Project Title: **Proposed Depot**
Plot north of Little Trees Springs,
Celtic Springs Business Park,
Spooner Cl, Newport NP10 8FZ

Drawing Title: **Proposed Site/Roof Plan**

Scale 1:250	Sheet Size A1	Drawn by 003	Checked by 001
Date 02/10/2025	Job No. 1350	Drawing No. P.02	Revision A

PROPOSED SITE/ROOF PLAN

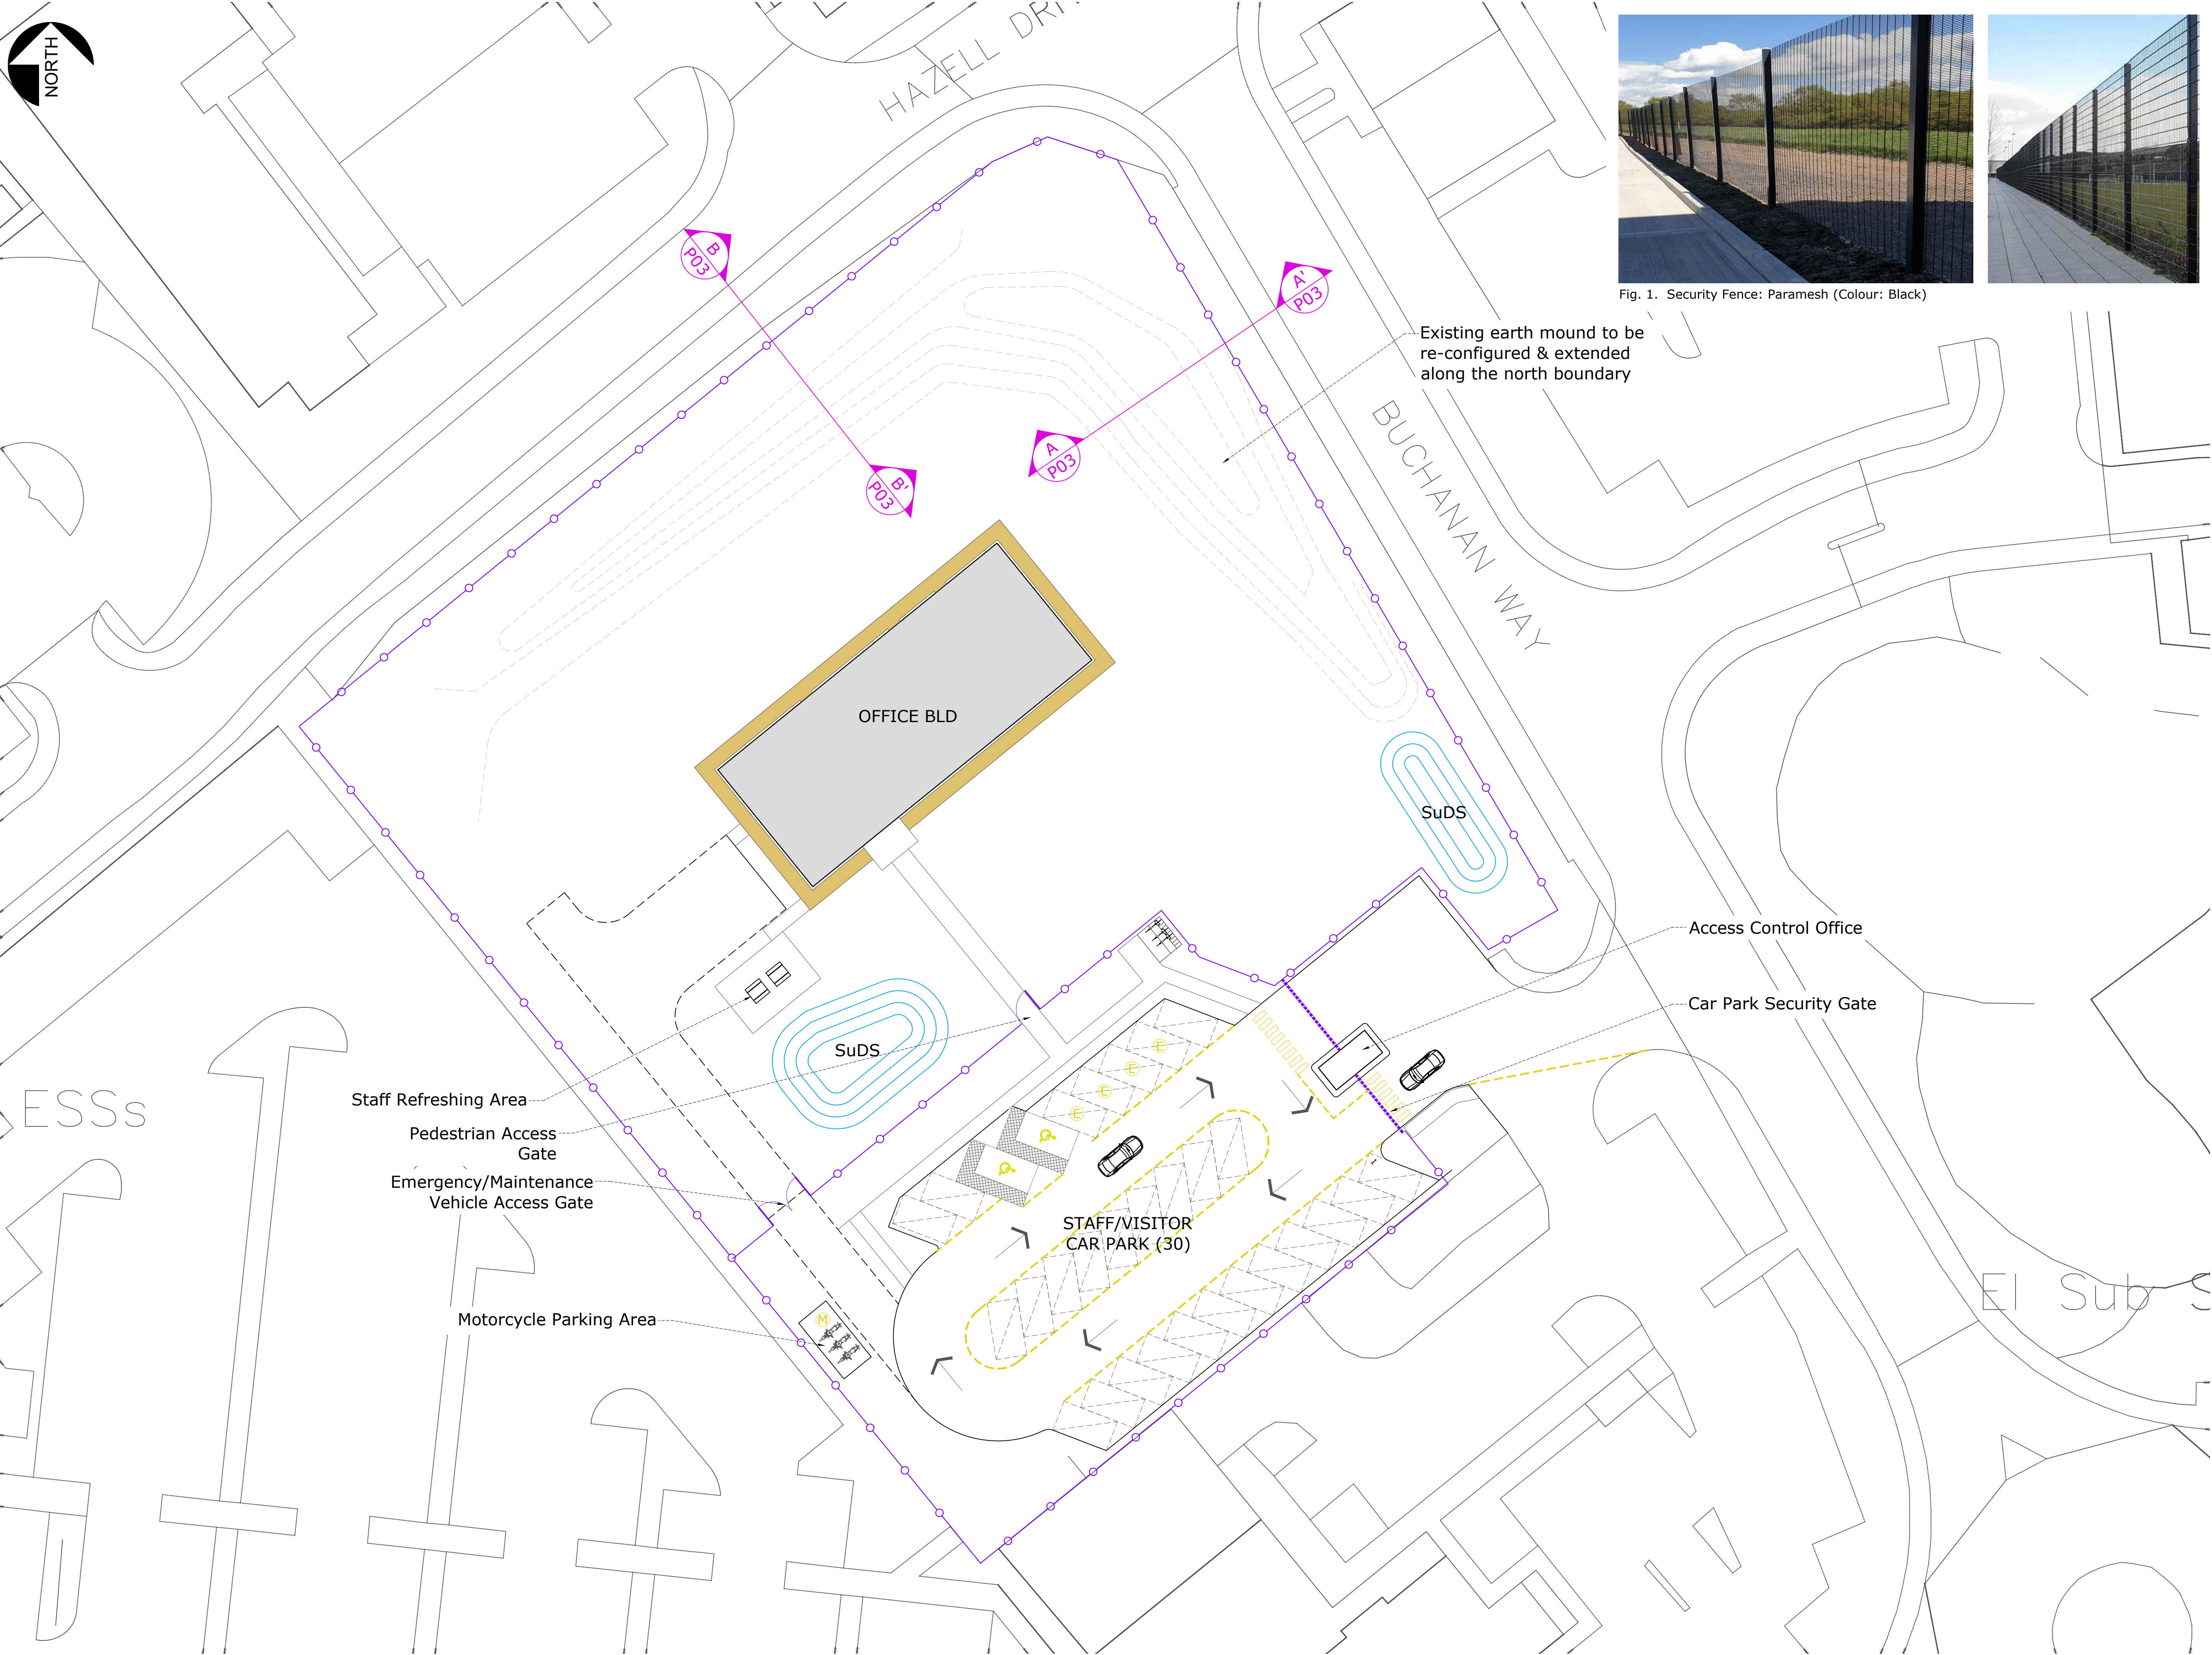
A	Fence line updated to planning officer's comments & earth mound added	003	11/12/25
Rev.	Description	By	Date
